· 0 ·			
COLORADO DEPARTMENT OF	Original NEPA	Reevaluation	Project Code: AQC			
TRANSPORTATION	Approval Date:	Date:	R600-165			
REEVALUATION FORM	1/19/2017	9/5/2018	Subaccount: 13599			
Project Name and Location: Central 70 Project: Reevaluation #4, I-70 from I-25 to Chambers Road						
NEPA Document Title: I-70 East ROD 1: Phase 1 (Central 70 Project) (January 19, 2017)						
Region/Program/Residency: Headquarters – Central 70 Project Office

Through the procurement process, the proposers were allowed to propose Alternative Technical Concepts (ATCs) for ways that would improve the project. This reevaluation covers the changes proposed through the ATC process and included in this project, except ATC 11.2, which will be covered in a future reevaluation. ATCs included in the project and do not change impacts or modify the alternative selected in the ROD are described and listed in **Attachment #1**. The remaining ATCs are included in the body of this reevaluation with a description, description of changes in impacts and any changes in mitigation.

Figure 4 - ATC 12.2 design off-site storm sewer routing connecting to GLO

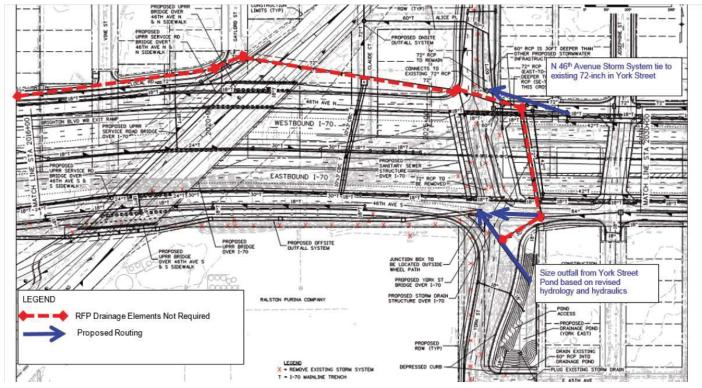
ATC 12.2 – This ATC will eliminate the 72 inch storm sewer bridge over I-70 mainline by connecting to the Offsite Outfall System that was previously identified in Reevaluation #1 dated 9/18/17. See **Figure 4.** The offsite system conveys drainage that originates

- The new routing scenario will add approximately 230 cubic feet per second to the Offsite Outfall System from where it connects near the southwest corner of I-70 and York Street to the Offsite Outfall's connection with the CCD GLO outfall system.

- ATC 12.2 will eliminate approximately 1,200 linear ft. of pipe. This allows for a reduction of equipment operating times and number of haul trucks through the cycle of producing, delivering, laying, and backfilling of the pipe, further reducing Project impacts.

Figure 6 - ATC 28.1 design of I-270 On-Ramp

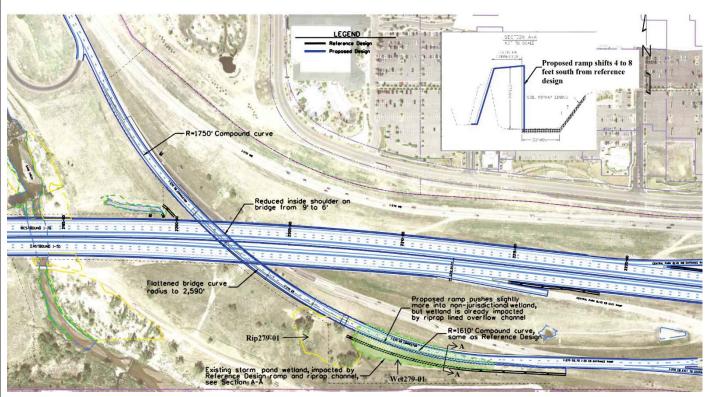
ATC 28.1 - Reduce the inside shoulder width from 9 ft. to 6 ft. on the flyover bridge while maintaining the required horizontal stopping sight distance (HSSD) for the traveling public along I-270 by flattening the radius of 2,184 ft. to a radius of 2,590 ft. See **Figure 6**.

- The proposed geometric adjustment provides for the reduction of bridge deck area on the flyover bridge, while also allowing the use of two girders instead of three for the entire bridge length. Utilize a 4 ft. inside shoulder for the portions of the EB Connector where no barrier obstructs sight distance.
- The retaining wall at the southeast end of the ramp will extend 4 to 8 feet farther south.
- There is a small reduction of impact to riparian habitat associated with this ATC. as shown in **Figure 9**. The riparian area's impact is decreased from 0.566 to 0.563 aces of permanent impacts and decreased from 0.074 to 0.072 acres of temporary impacts.
- The wetland WET-279-1 is identified in the Updates to Wetlands and Other Waters of the U.S. Technical Report Addendum (January, 2017) as totally impacted, therefore there will be no additional wetland impacts from this ATC.

Figure 7.2 ATC 68.0 avoids the right-of-way, ground disturbance, and temporary traffic impacts in the ROD by eliminating the route for the On-Site Storm Sewer that was included in the ROD

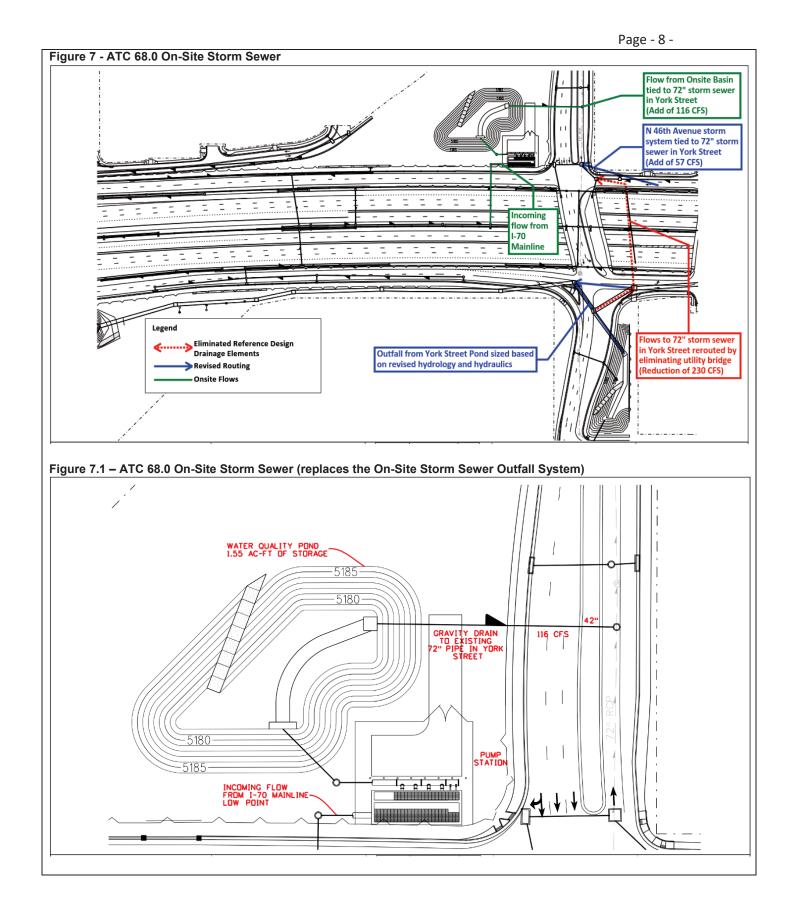
ATC 68.0 - Modify the Onsite Outfall system to optimize the existing right-of-way and existing drainage infrastructure and eliminate the north outfall included in the ROD. See Figures 7, 7.1, and 7.2

- ATC 68.0 will reduce the temporary wetland impacts to OW-N_Culv_03 by 0.005 acres. ATC 68.0 will reduce the permanent riparian impacts at Rip_Culv03 by 0.002 acres and the temporary impacts by 0.012 acres.

- ATC 68.0 will eliminate Project construction activities in one affected Solid Waste Landfill location.
- ATC 68.0 eliminates the temporary impacts on the South Platte River Greenway, a Section 6(f) resource.

The elimination of the ROD's Onsite Outfall System and redesign using project Right-of-Way and existing drainage systems described in ATC 68.0 allows for removing 2.153 acres of Right-of-Way and 2.083 acres of Permanent Easements. See **Figure 7.2**.

Figure 8 - Location where impacts are eliminated to OW-N_Culv_03 and Rip_N_Culv_03

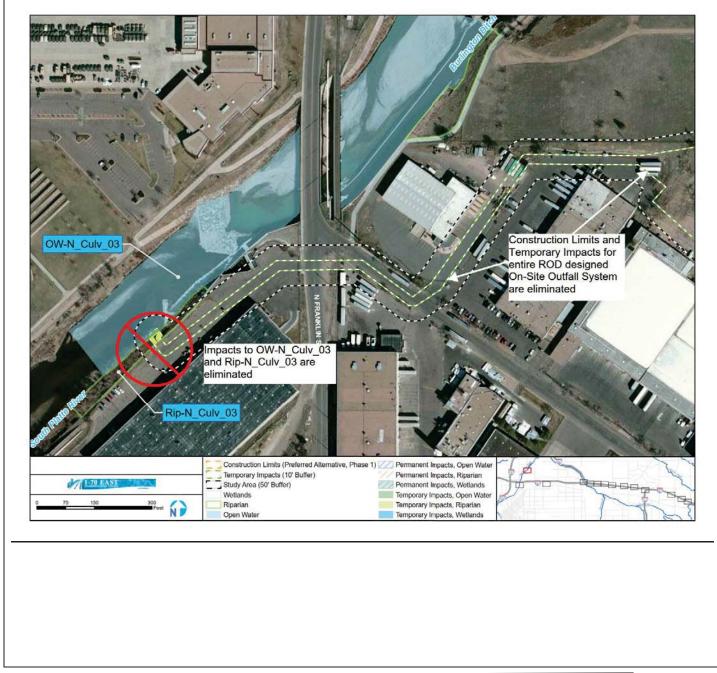
Temporary impacts of 0.005 acres to OW-N_Culv_03 previously identified in the 2017 Wetland Findings Update are eliminated with changes based on ATC 68.0. See **Figure 8**.

The removal of the Onsite Outfall as part of ATC 68.0 results in the reduction of temporary impacts to riparian habitat by 0.012 acres and permanent impacts by 0.002 acres at Rip N Culv 03. See Figure 8.

Figure 9 - ATC 28.1 Impacts to Riparian Area

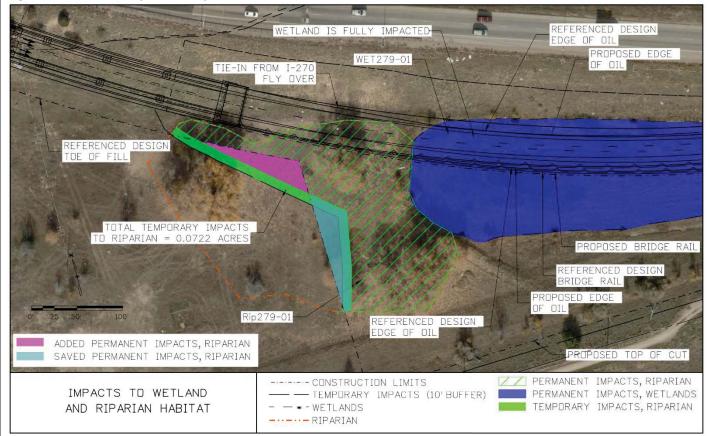
Permanent impacts to riparian habitat due to the ATC 28.1 has decreased from 0.566 to 0.563 acres and temporary impacts have decreased from 0.074 to 0.072 acres. See Figure 9.

Figure 10 - Location of eliminated impact on South Platte River Greenway (6(f) resource)

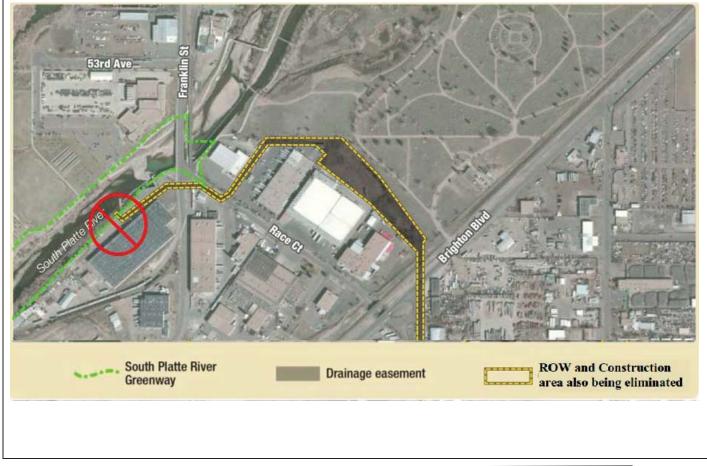
The elimination of the ROD's Onsite Outfall System and redesign using project Right-of-Way and existing drainage systems described in ATC 68.0 eliminates the temporary impacts on the South Platte River Greenway, a Section 6(f) resource. See **Figure 10**.

Figure 11 - Location of reduced area of disturbance and reduction in hazardous site by eliminating ROD designed onsite outfall system

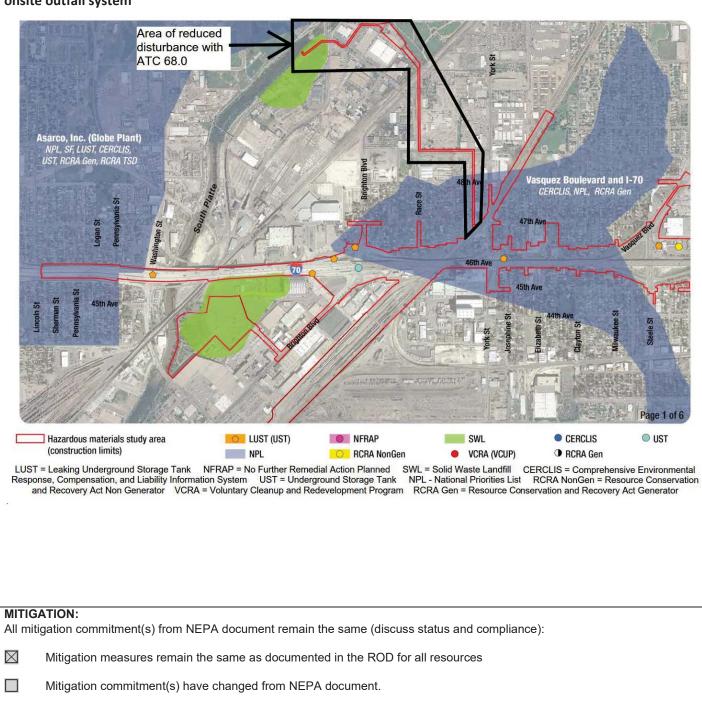
ATC 68, resulted in approximately 6 less acres of disturbance than the ROD as shown in **Table 3** (Also see **Figure 7.2** and **Figure 11**), within the Vasquez and I-70 National Priorities List (NPL) site, Operable Unit 1 (OU1). The NPL site was listed due to metals contamination associated with historic smelter operations and the OU1 area was the subject of an EPA 2003 Record of Decision detailing residential soils contamination and EPA's cleanup decision. There is also a subarea identified as CERCLIS and RCRA Generator through which approximately 900 linear feet of excavation, an average of 40 feet deep, are avoided due to ATC 68.
